## **DRAFT RESOLUTION**

**SIGNAL HILL LLC (PLN240077)**

**RESOLUTION NO. \_\_\_\_\_**

- 7) Amend Condition No. 23 of Resolution No. 23-237 to increase the conservation scenic easement for the project to 1.67-acre area.
- [1170 Signal Hill Road, Pebble Beach, Del Monte Forest Area Land Use Plan (APN: 008-261-007-000)]

**ARCHITECTURAL PLAN  
ELEVATIONS**

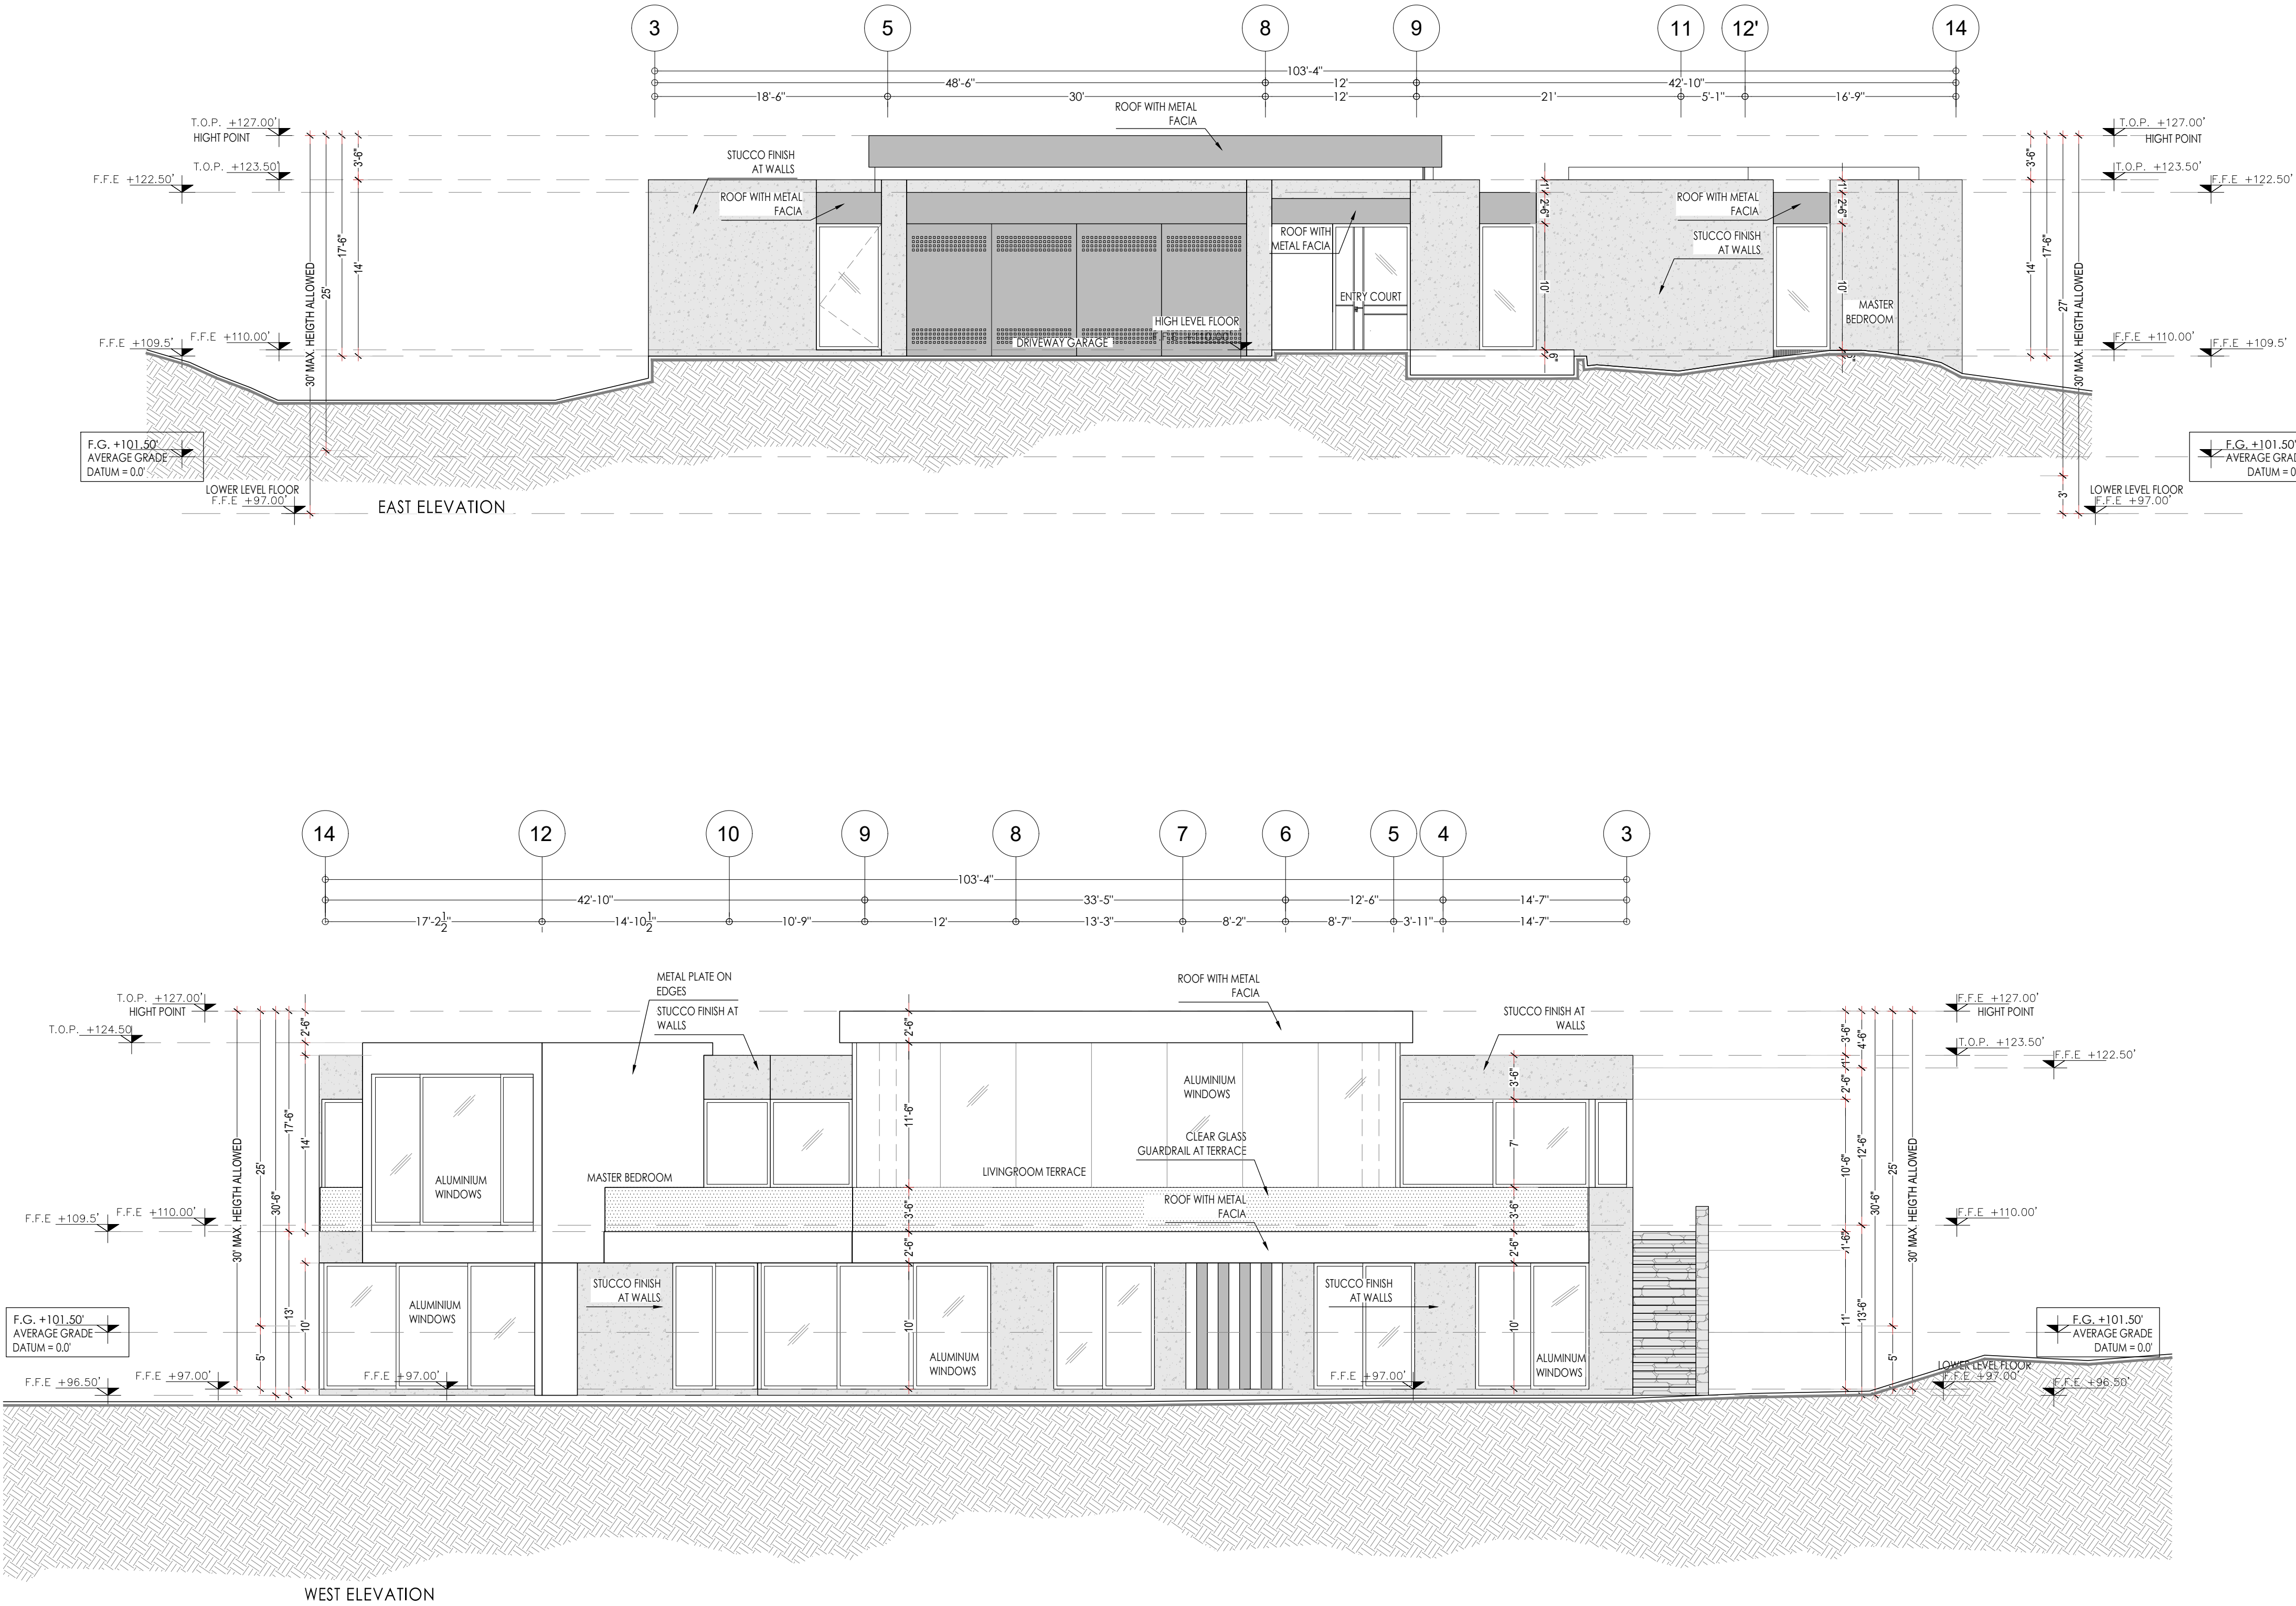
PLN240077 draft plans demonstrate most roof heights in the new design at approximately 22 feet ANG, with a great room reaching approximately 25.5 ANG. The view from Signal Hill Road is shown in the east elevation of the plans attached to the Board Resolution. From Signal Hill Road, the structure will appear to be 17.5 feet in height. The view from 17 Mile Drive is shown in the west elevation; the appellant is correct that the façade at its highest point would appear to be 30 feet high. However, County zoning codes measure from ANG and, in this case, the project design is approximately 4.5 feet less than the maximum allowable height from ANG.
